File Number: 10-D-26-DT

Meeting: 10/21/2026
Applicant: Knoxville Hotel Partners, LLC
Owner: Alpesh Patel Embassy Suites Knoxville
Project: Embassy Suites

Location: 507 S. Gay St. **Parcel ID:** 94 L E 01901
Zoning: DK-H (Downtown Knoxville, Historic Subdistrict)
Description: Minor alteration/addition
Multi-story modern concrete hotel building with multiple commercial storefronts along Gay Street and Union Avenue.

2 BALCONY SECTION
1/8" = 1'-0"

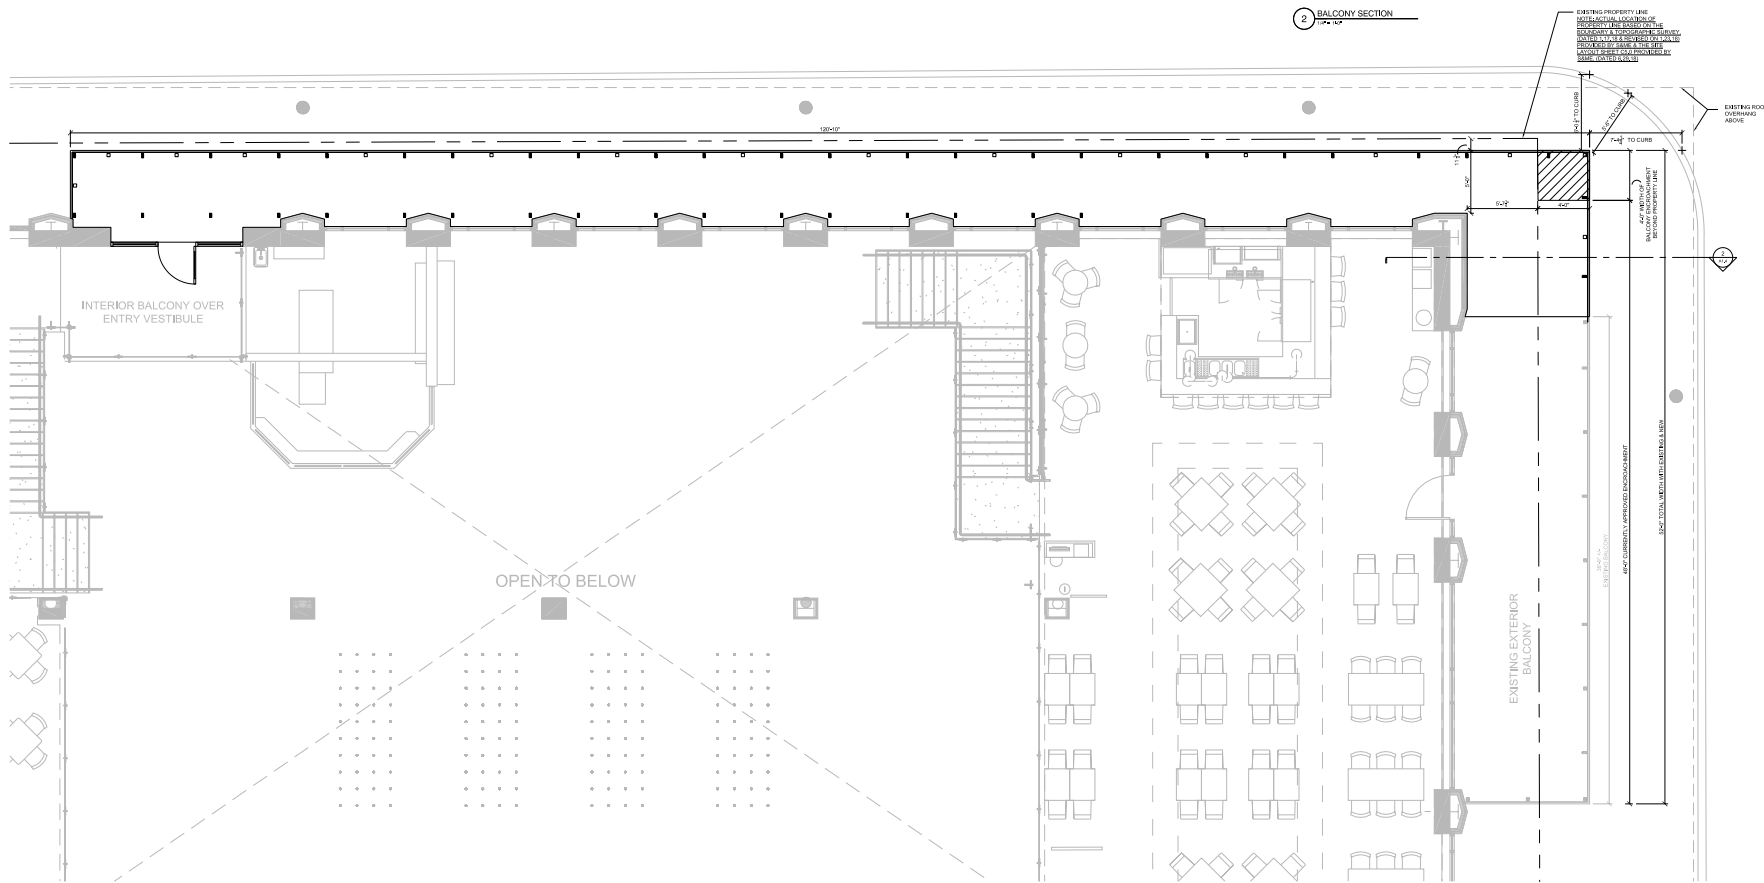
UPDATE: This request is for reconsideration of the raised glass guardrail. The board approved a Certificate of Appropriateness (9-A-26-DT) for this project last month, with the condition that the glass guardrail be the same height across the entire balcony by implementing planters or other permanent fixtures, pending approval from both Engineering and Planning staff. For safety reasons, City Engineering is not comfortable approving planters or other permanent fixtures.

BALCONY: The new balcony will have an 11'-0" sidewalk clearance and will match the existing balcony on the Gay Street elevation in design, material, and color (see Exhibit B). The balcony has a maximum depth of 10'-9" on the

Gay Street elevation, and 6'-0" on the Union Avenue elevation. The glass guardrail will be 5'-0" tall and 4'-0" wide when adjacent to a Union Avenue streetlight for safety purposes. Otherwise, the glass guardrail will be 3'-6" tall. Structural hangers will support it on the outside and inside edges of the balcony, aligned with the outside edges of the existing second-story storefront systems.

Staff recommends approval of Certificate 10-D-26-DT subject to the following conditions.
1) Meeting all applicable standards of the Zoning Ordinance.
2) Meeting all applicable requirements of the City's Department of Engineering.

1 ELECTRICAL GROUND LEVEL LIGHTING PLAN
E1.1 SCALE: 1/4" = 1'-0"

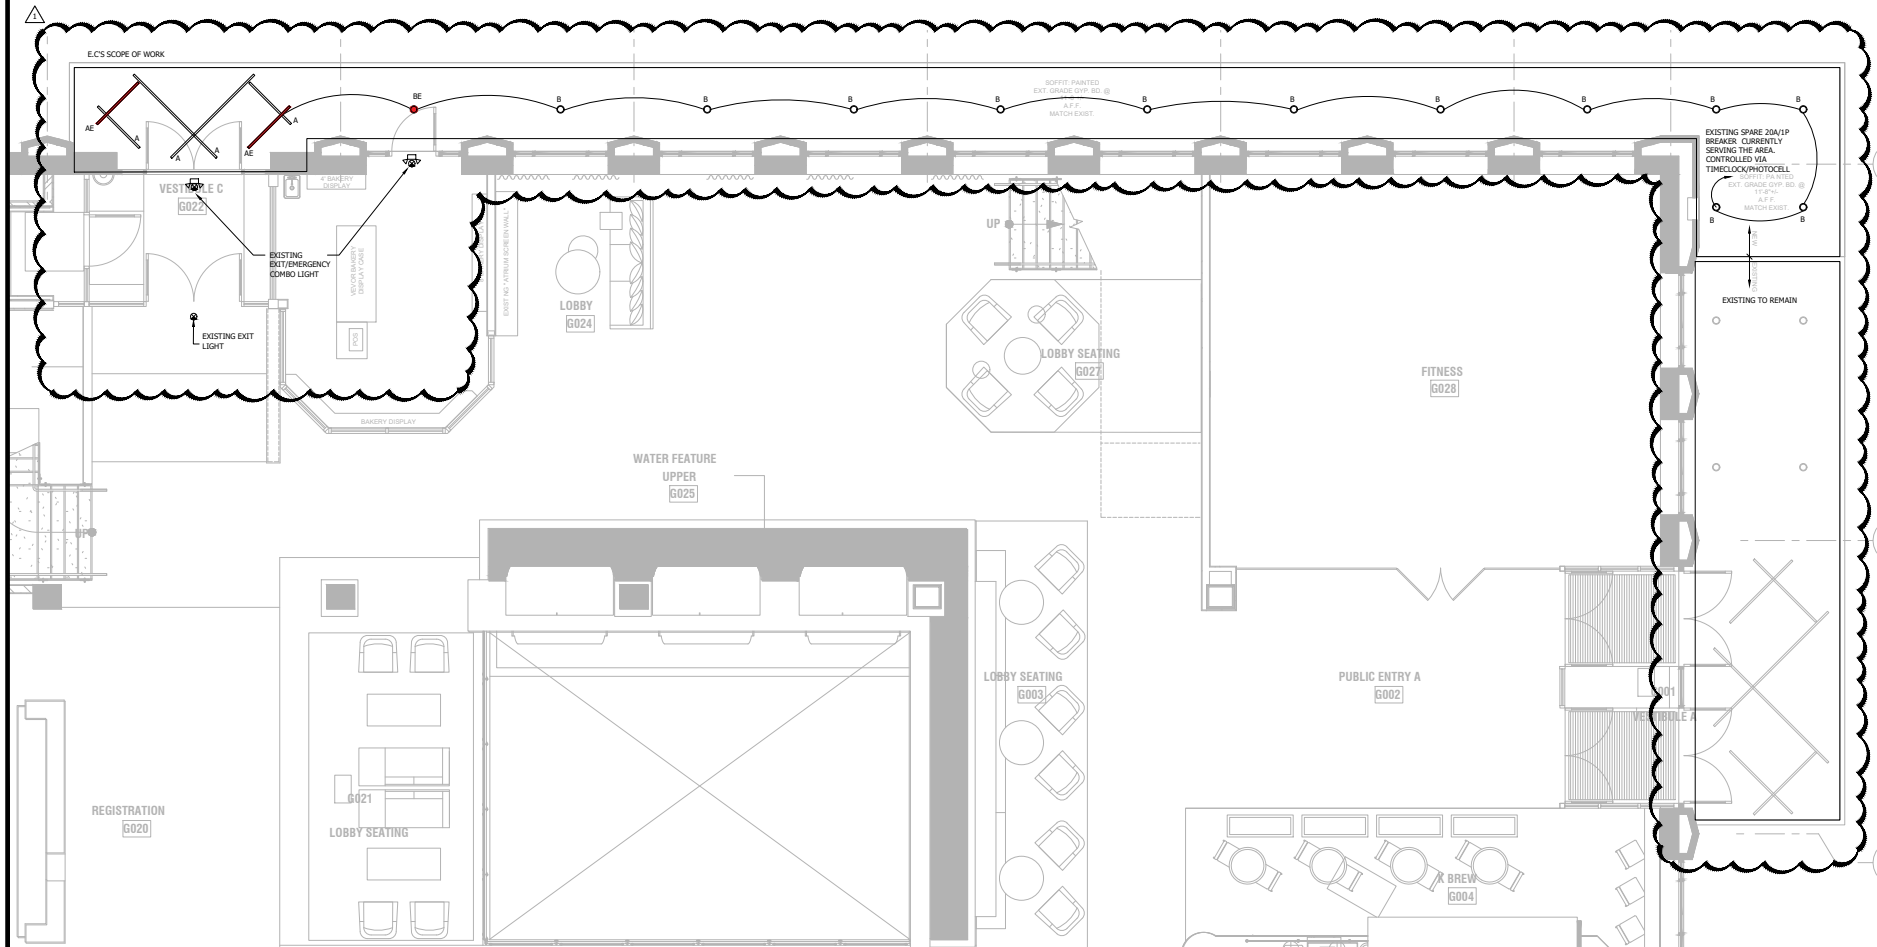
LIGHTING: The underside of the new balcony will have round lights along most of its length, and LED tape lights at the Union Avenue ground-floor entrance. The lighting will match that on the existing Gay Street balcony.

PEDESTRIAN AND BICYCLIST SAFETY: The lighting on the underside of the canopy will supplement the streetlights, which the canopy will partially block.
